HARTZELL PROPELLER INC.
SERVICE LETTER

HM-SL-002

Propeller - Hub Clamping Bolt Inspection

**Hex Head Bolt
Figure 1**

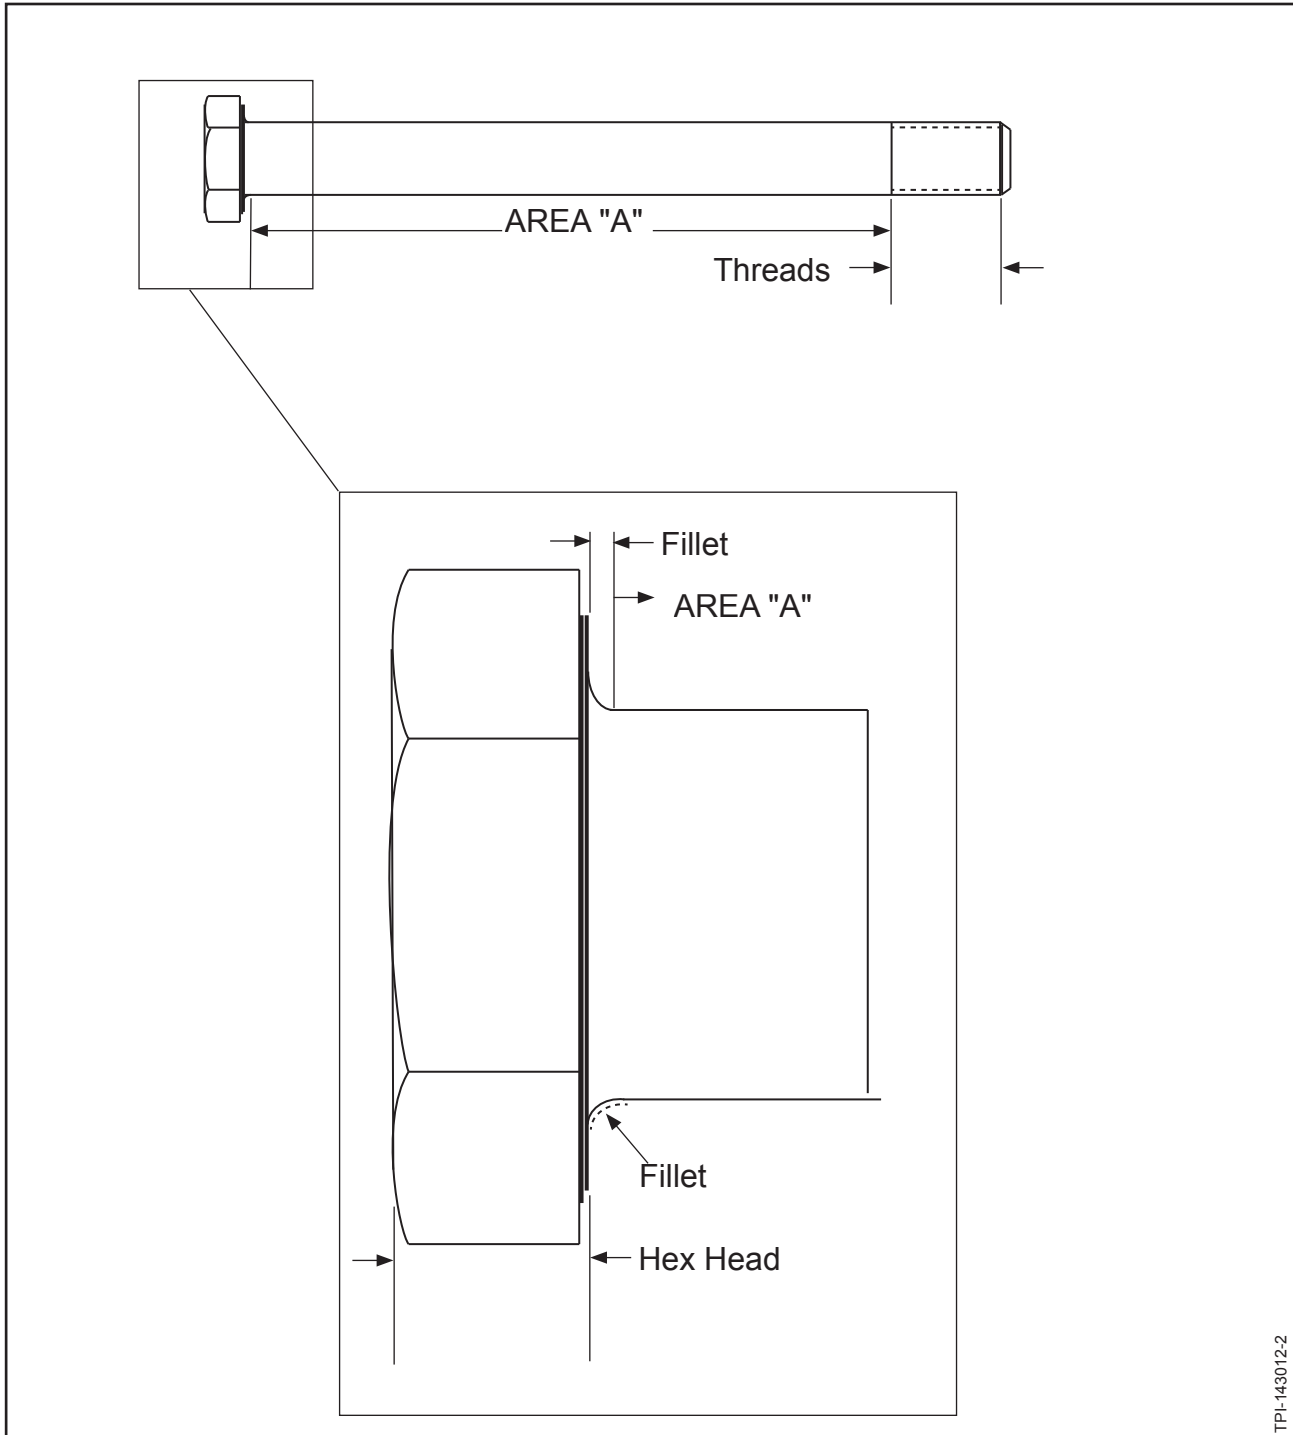
Inspect	Serviceable Limits	Corrective Action
<u>HEX HEAD BOLT</u>		
Refer to Figure 1.		
(1) Visually examine the hex head bolt for corrosion and pitting.	Corrosion is not permitted. The maximum permitted depth of pitting is 0.002 inch (0.05 mm). No more than 5% of the total unthreaded surface may be pitted. The maximum permitted diameter of an individual pit is 0.032 inch (0.81 mm). Pitting is not permitted in the fillet between the hex head and the grip, area "A". Pitting must not affect the fit or function of the hex head bolt.	Corrosion may be removed using glass bead cleaning. Refer to the Cleaning chapter of Hartzell Propeller Inc. Standard Practices Manual 202A (61-01-02). If the pitting is greater than the permitted serviceable limits, replace the hex head bolt.

(2) Except for the threads, visually examine the hex head bolt for damage or scratches.	The maximum permitted depth of damage or a scratch is 0.002 inch (0.05 mm). Scratches or damage must not affect the fit or function of the hex head bolt. Pushed-up material is not permitted.	Pushed up material may be removed. If the depth of a scratch or damage is greater than the permitted serviceable limits or affects the fit or function of the bolt, replace the hex head bolt.

(3) Visually examine the hex head bolt for circumferential scoring caused by installation and removal.	Circumferential scoring that reduces the diameter of the hex head bolt is not permitted. The minimum permitted OD in Area A is 0.370 inch (9.40 mm).	If the scoring is greater than the permitted serviceable limits or the OD in Area A is less than the serviceable limits, replace the hex head bolt.

(4) Visually examine the wrenching surfaces of the head of the hex head bolt for metal movement caused by wrenching.	Limited damage from wrenching is permitted, but the hex head bolt must be able to be torqued and metal movement must not interfere with the installation of the hex head bolt or cause damage to the hub.	Remove metal movement with a file or equivalent. Only corners may be repaired. Refacing a complete surface is not permitted. If metal movement is greater than the permitted serviceable limits, replace the hex head bolt.

Inspect	Serviceable Limits	Corrective Action
<u>HEX HEAD BOLT, CONTINUED</u>		
Refer to Figure 1.		
(5) Visually examine the threads of the hex head bolt for damage and pitting.	A maximum total accumulation of damage and pitting of 3/4 thread is permitted. Thread damage must not cause damage to the mating part. An A-2043-1 nut with the plastic locking element removed should be able to freely rotate by hand on the bolt threads. For the modification of the nut, refer to Figure 2.	Limited thread file repair is permitted, but must be considered as thread damage. If the damage and pitting is greater than the permitted serviceable limits, replace the hex head bolt.

(6) Magnetic particle inspect each bolt in accordance with the Magnetic Particle Inspection chapter of Hartzell Propeller Inc. Standard Practices Manual 202A (61-01-02). <u>NOTE:</u> It is not necessary to strip the cadmium plating from the hex head bolt before magnetic particle inspection.	A relevant indication is not permitted.	If there is a relevant indication, replace the hex head bolt.

(7) Visually examine the hex head bolt for cadmium plating coverage.	Cadmium plating must completely cover the bolt with the following exceptions: A few scratches and corners with cadmium plating missing, minor abrading of cadmium plating on the threads, or minor abrading of the cadmium plating on the hex head because of wrenching.	Cadmium replate and bake for a minimum of 23 hours within four hours after plating the hex head bolt in accordance with the Cadmium Replating chapter of Hartzell Propeller Inc. Standard Practices Manual 202A (61-01-02).
